Technical Review of Pak Beng Hydropower Project – (1) Hydrology & Hydraulics and (2) Sediment Transport & River Morphology

*The 2nd Regional Stakeholder Forum
The Pak Beng Hydropower Project
5th May 2017
Vientiane, Lao PDR*

Method of flow determination

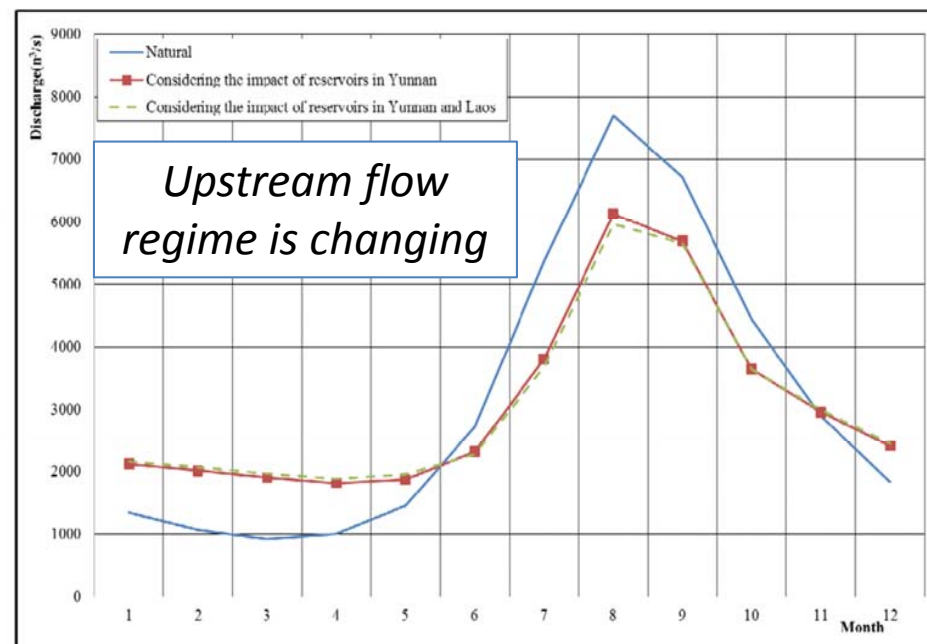
- Upstream dams in China are likely to affect the **flood peak determinations** for Pak Beng dam design.
- **Higher flows** may occur less frequently while **base flows** in the dry season may be higher

→ *It is important to cross-check, improve and verify flood peak determination.*

Sediment data

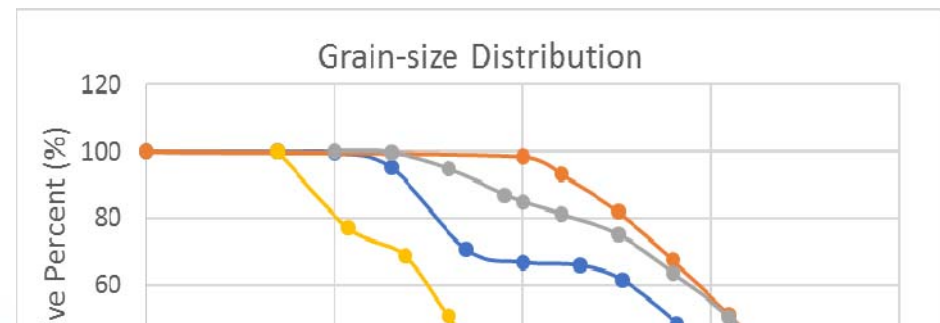
- Sediment loads based on **pre-Lancang Cascade** measurements in China & extrapolated to Pak Beng.
- Limited **actual sampling** of bed load.
- Grain-size distribution of suspended & bedload based on **limited measurements** in June 2008 and 2015 at Pak Beng or Luang Prabang.
- No '**ground truthing**' with present conditions at Pak Beng.

→ ***Additional sediment monitoring is recommended to confirm suspended sediment and bed load and its characteristics.***

Sediment modelling

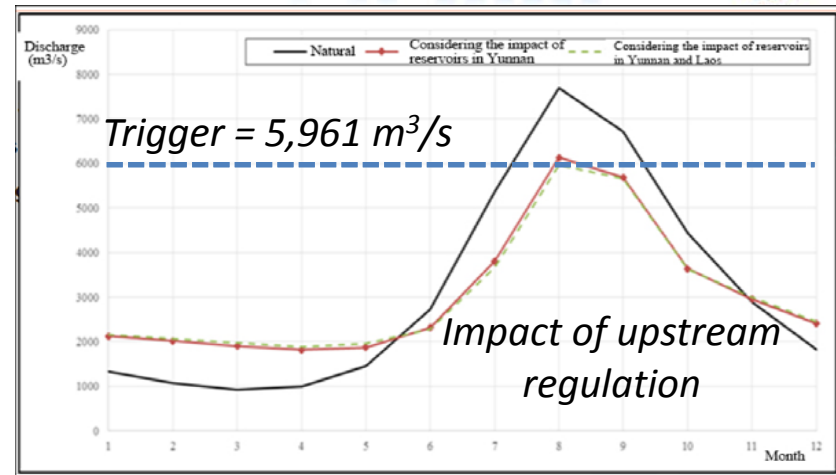
- Range of models have been applied and run at different time with **limited calibration** to **site-specific data**.
- **Detailed sediment** modelling only applied to area near project infrastructure
 - Lack of detail about sediment accumulation in reservoir
 - Lack of detail about seasonality or grain-sizes discharged downstream
- Lack of **geomorphic mapping** or modelling of downstream channel

→ *The range of sediment models should be reviewed, cross-checked and updated once additional data is collected through monitoring.*

Fig. 7.2-2 Sediment Deposition at Section 2

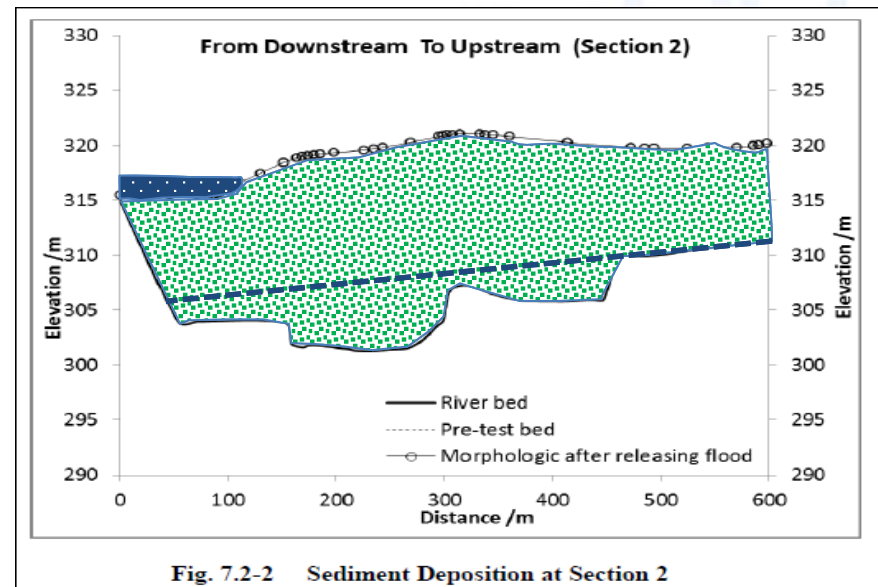
- Flushing is likely to have a **limited effect** due to the **high sill level** at the sluice gates.
- **Low level outlets** only remove sediment in front of the power house inlets.

- **Bedload** effectively trapped upstream of dam and

→ *Lower sill level increases water surface slope & depth of sediment flushing.*
